MOONEY AIRCRAFT, INC.

SERVICE LETTER 20-10

SERVICE BULLETIN M 20-10

SUBJECT: Kit-Upper door pin striker plate.

E.O. 20-10 NO DRAWING  
STRIKER PLATE INSTALL - UPPER LOCK PIN  
REASON - UPPER DOOR PIN CAUSES WEAR ON  
3222 AL BHP.  
EFF. PT. - IN PRODUCTION SERIAL NO. 10454 ON  
SERVICE LETTER 20-10 (KITS)

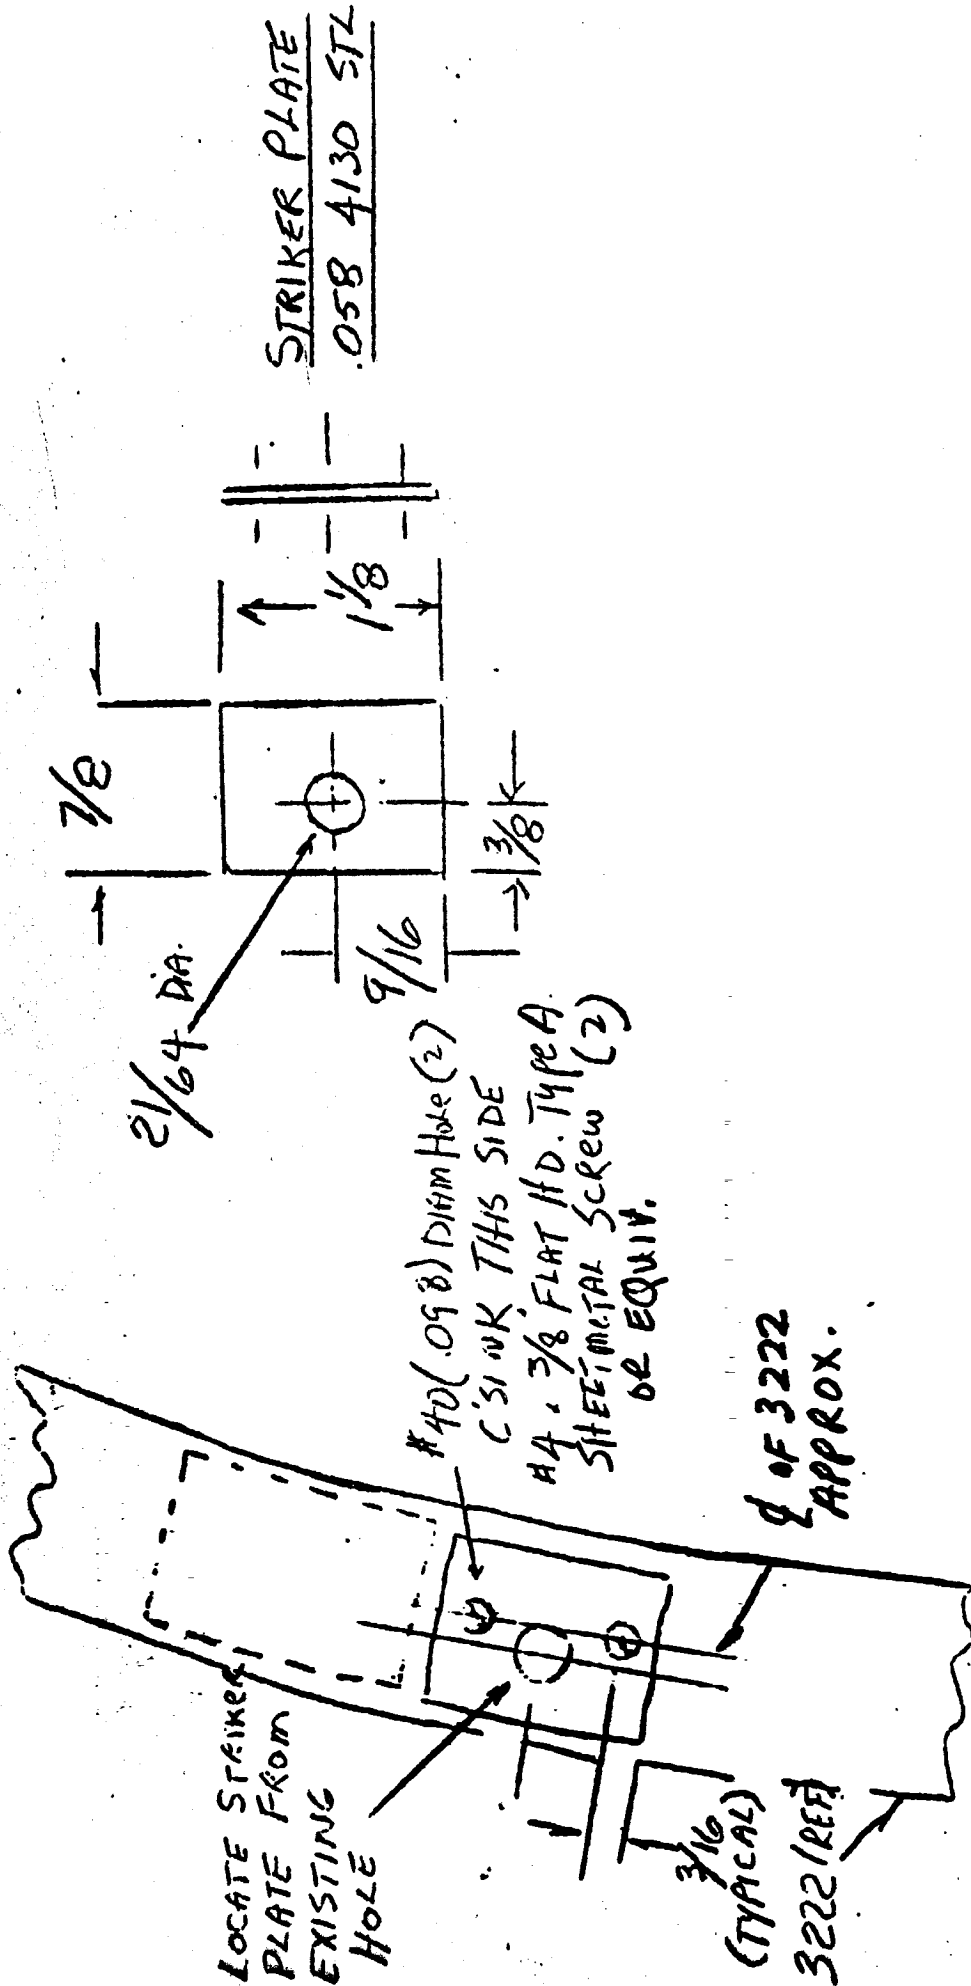
To eliminate the possibility of excessive wear to the aluminum door frame, it is recommended that the enclosed striker plate be installed in accordance with the enclosed EO 20-10.

STRIKER PLATE  
058 4130 STL

VIEW LKG AFT. AT DOOR FRAME  
UPPER AFT. RETRACTABLE  
PIN HOLE
